Geology and Hydrology of Kartchner Caverns and their Relationship to the Vigneto Development

Norm "Mick" Meader Cascabel Conservation Association and Lower San Pedro Watershed Alliance

July 1, 2016

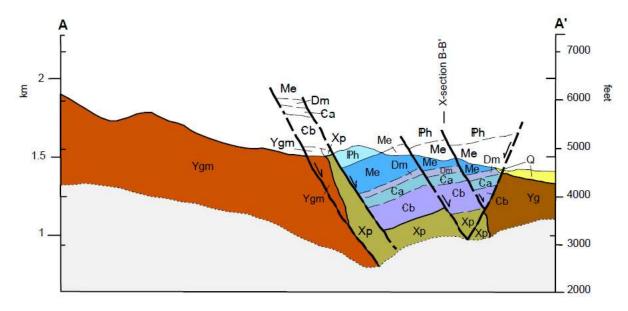
Shipman and Ferguson (2003) interpreted the faulting relationships within the Kartchner block from surface mapping and placed the limestone of the caverns in a graben bounded on the east by a west-dipping fault with a displacement of 1000 ft or more (Figure 5). Gravity and well data (Lange, 1999; Graf, 1999) clearly indicate that the trace of their inferred fault lies just west of the east-dipping fault that bounds the Kartchner block on the east, which has a displacement of up to 2,000 ft or more, given that no bedrock was encountered to a depth of 1200 ft in the Caverns LLC 2 well. I have added the approximate trace of that fault to their map (Figure 4). The trace of their graben-bounding fault is the dotted line. Shipman and Ferguson apparently did not consider Lange and Graf's gravity and well data in making their map. It is difficult to envision such large opposing displacements occurring back-to-back in this manner. The east-dipping fault noted by Graf and Lange will dominate the structural setting.

The geologic relationships that caused Shipman and Ferguson to postulate their down-to-the-west fault are circled in Figure 4. A fault is needed to explain the juxtaposition of Paleozoic rocks against Precambrian basement. The fault may possibly be much more local and shorter and accommodate the severe fragmentation of the Kartchner block, as the many other faults in the block do. The Kartchner block is part of a rotated fault block that has been highly deformed by being caught between two major basin-bounding, down-to-the-east faults (Figure 1) that

Figure 17. Modeled bedrock surface from Figure 9 of *Prucha* (2016). This model is taken from the original Modflow model for the basin done by *Goode and Maddock* (2000). The figure hints at a stepped-down basement architecture beneath the basin created by parallel Basin and Range normal faults.

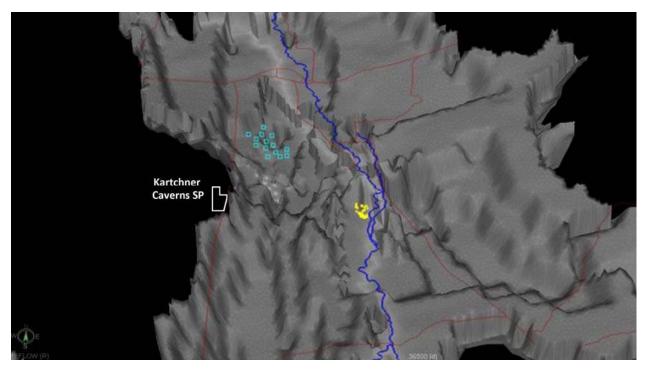
The basin margin is characterized by multiple, large-scale east-dipping faults, resulting in several parallel, rotated fault blocks, as shown schematically in Figure 16, some of which are now buried east of the mountain front. Prucha's Figure 9, included here as Figure 17, hints at this stepped architecture. The well that the Kartchner family drilled east of the park in 2005 passed through 1200 ft of alluvium, indicating that an east-dipping fault with at least that much displacement lies between the park and the well. These long, linear fault blocks are cut by cross faults as illustrated in Figures 4 and 18, which provide a network of hydrological connections. The primary faults that bound the Kartchner block trend northeastward into the heart of the Vigneto development and may act as conduits for water flow in that direction.

A more complete hydrological model for the Benson subbasin would combine the more horizontal and uniform porosity and permeability of the alluvial aquifers of the basin center with the more localized and dipping zones of porosity and permeability in the limestone aquifers around the basin margin. Determining the configuration of the network of faults, fractures, and dissolution channels in the limestone and their effective hydrologic conductivity would be the most difficult parameters to establish.

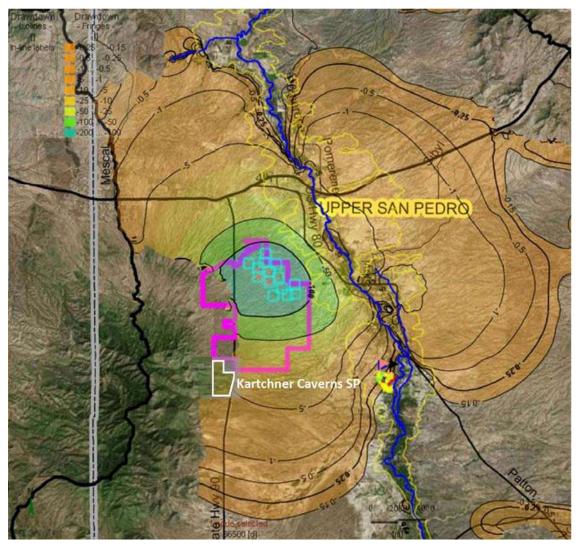
Combining these two aquifers in an integrated model is worth considering given how water saturates and fills every possible pore and pathway beneath the water table. Water continuously flows down gradient through any available avenue depending on permeability and the hydraulic gradient. If the Prucha model is reasonable (Figure 19) in predicting the extent of water drawdown by Vigneto pumping, that drawdown might affect the limestone aquifers in fault blocks around the basin margin. While the predicted effect of drawdown opposite the caverns is small (5 m or 16 ft) and would at first seem inconsequential, of greater hydrologic concern may

be the increased transfer of water along strike to the northeast through the network of highly permeable faults and related solution channels. These faults and channels would facilitate much stronger water transport in that direction. The existence of limestone bedrock in Whetstone Ranch well EX-A supports this possibility.
